AESTHETIC SURGERY ASSOCIATES MEDICAL OFFICE BUILDING
MAJOR PLAN 2023-106
ATTACHMENTS

TO: PLANNING COMMISSION
FROM: GREGG ADAMS, PLANNER
SUBJECT: AESTHETIC SURGERY MEDICAL OFFICE BUILDING
MAJOR PLAN 2023-106
REQUEST FOR PRELIMINARY/FINAL PLAN REVIEW
DATE: FEBRUARY 2, 2024
COPIES: BOARD OF COMMISSIONERS, T. PETRUCCI, D. MANHARDT,
L. HARRIER, L. PEREIRA, ESQ, A. TALLARIDA, S. PIDCOCK,
APPLICANT, SUB. FILE 2023-106

SUBJECT: South Whitehall Township
Aesthetic Surgery Associates MOB
Major Plan #2023-106
Preliminary/Final Plan Review

RE: Geotechnical Engineering Review of
Provided Documents
Aesthetic Surgery Associates
Medical Office Building Major Plan 2023-106
South Whitehall Township, Lehigh County,
Pennsylvania
Hanover Project SWT23-11(017)

EXISTING CONDITIONS/ DEMOLITION PLAN

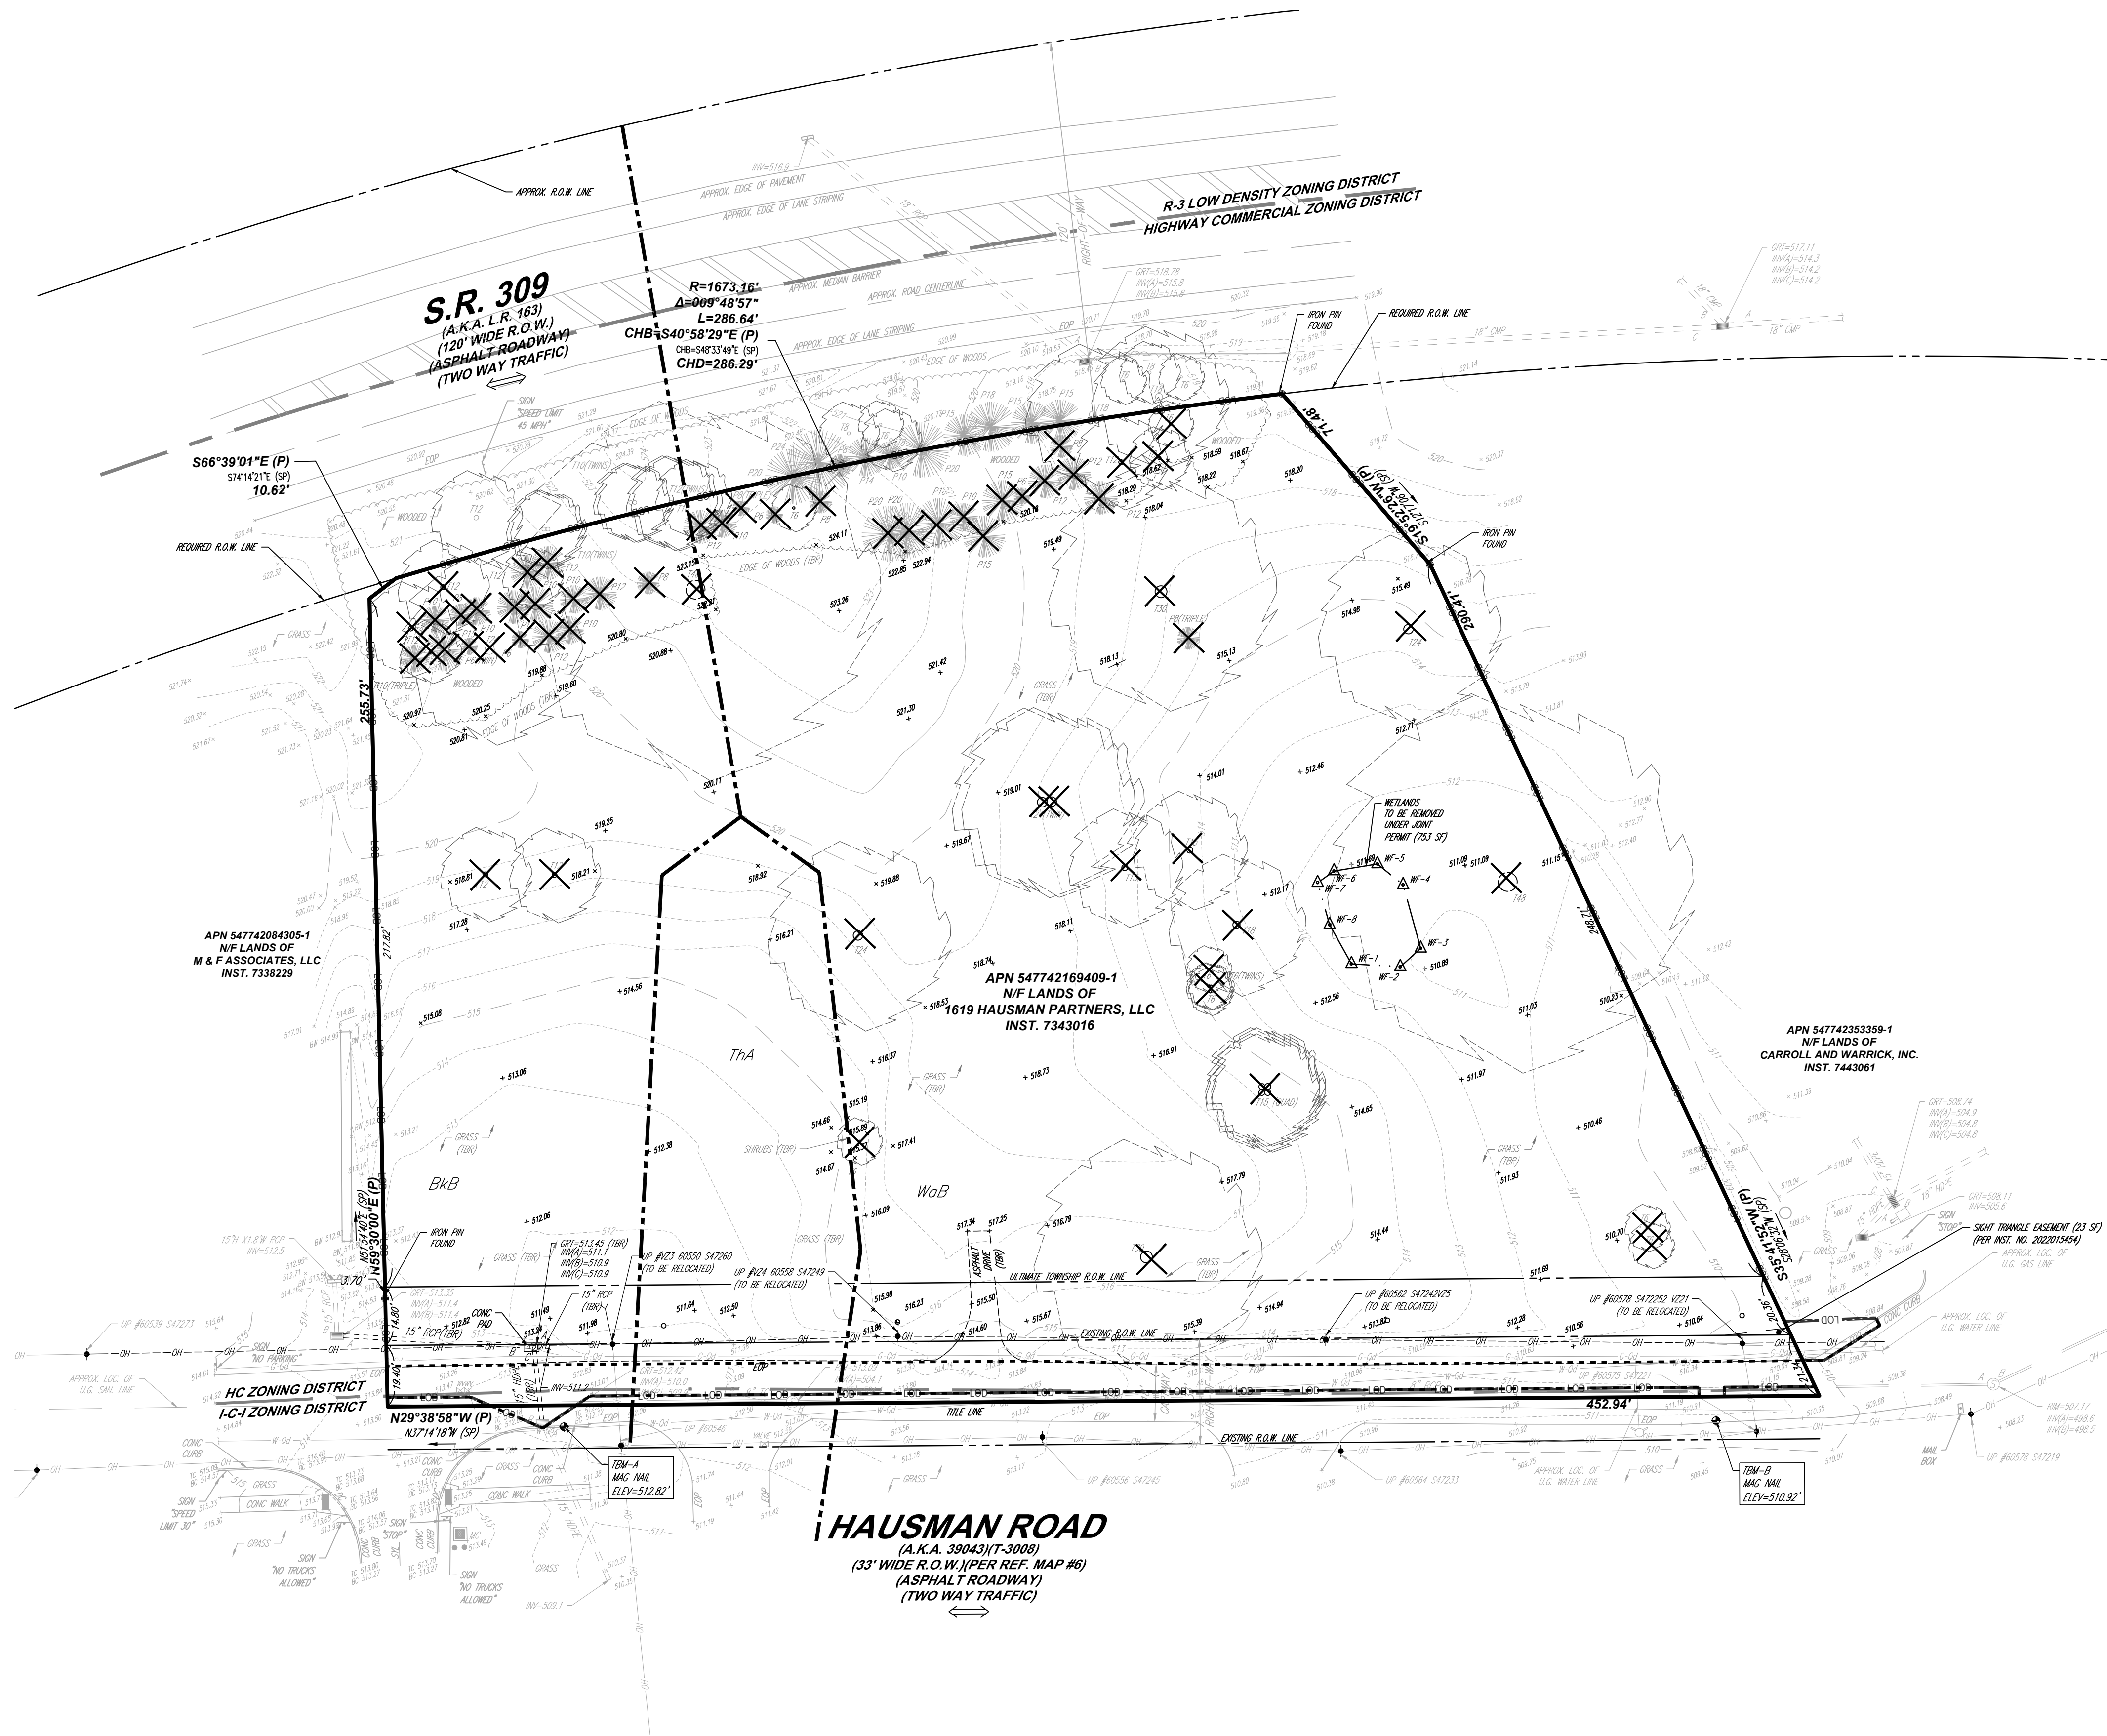
4. On Sheet C-201, a closed depression is indicated by the closed 511 contour line on the south side of the property. This feature shall be investigated and characterized concurrent with the additional soil testing per the above comment. If found to be karst in nature, the feature shall be labeled on the plans and remediation measures shall be provided in the plan notes.

SHEET TITLE:
LIGHTING PLAN
SHEET NUMBER:
C-703
ORG. DATE - 01/04/2024

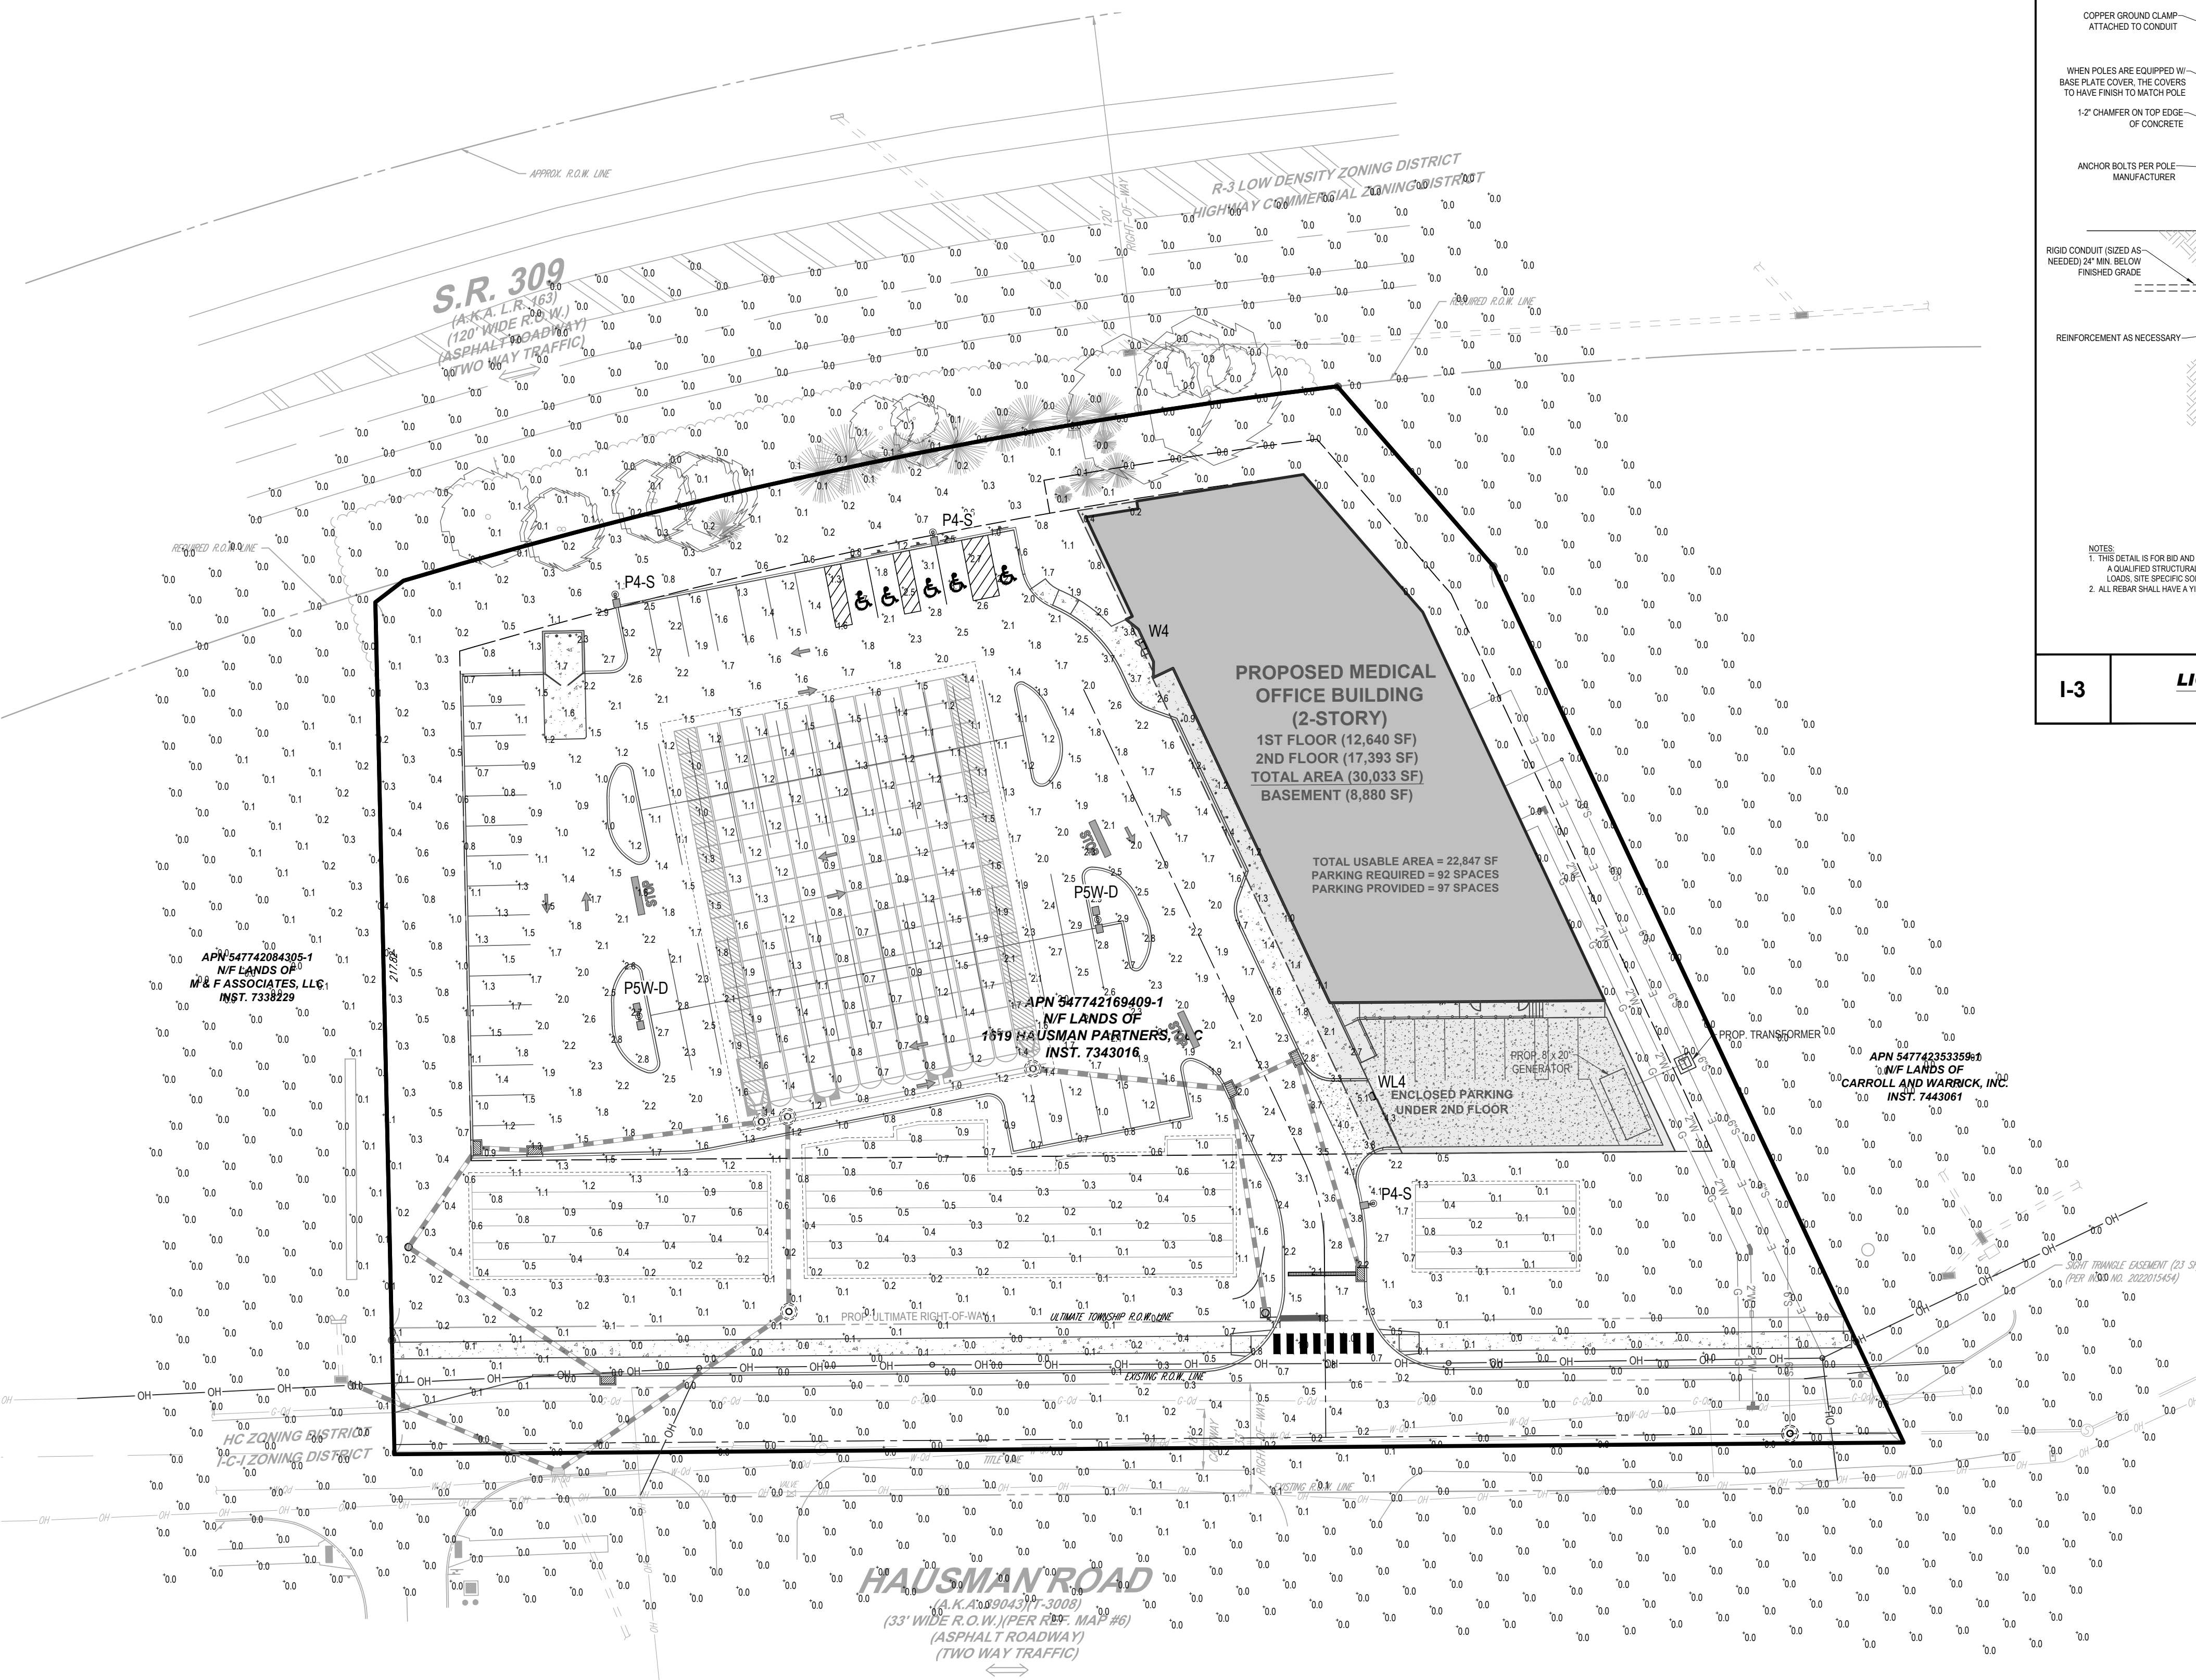
6. A note shall be added to the plan (in the Light pole Foundation Detail on Sheet C-703) stating that a building permit is required for light pole foundations prior to installation.
